E8361C-07 <u>S E R V I C E N O T E</u>

E8361C PNA Microwave Network Analyzers

An enhancement added to absorb vibration when opening the swing deck during hardware repair.

Figure 1

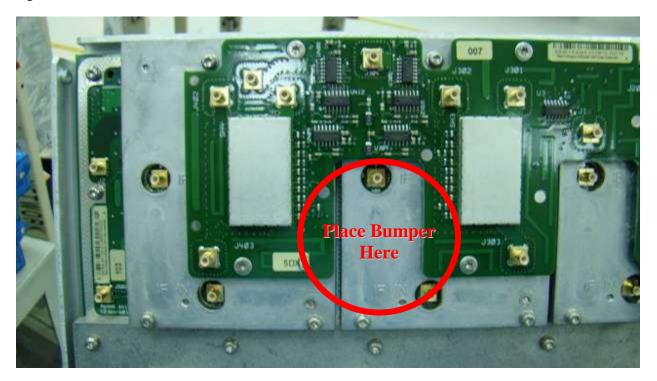
A rubber bumper – E8361-40001 is available to improve the serviceability of the instrument. This will also ensure the swing deck well separated from other nearby assembly.

- 1. Go to http://na.tm.agilent.com/pna/documents.html.
- 2. Click on the appropriate Service Guide.
- 3. When the PDF of the Service Guide is displayed, look at the bookmarks in the left column. Expand the Contents section by clicking on the plus sign next to its bookmark.
- 4. Scroll through the Contents section bookmarks to locate "Repair & Replacement Procedures."
- 5. Click on the title/hyperlink for the section "Receiver Deck."
- 6. Follow the instructions in the subsection "Raising and Lowering the Receiver Deck."
- 7. Once the Receiver Deck has been lower, installed the Bumper as shown in Figure 2.
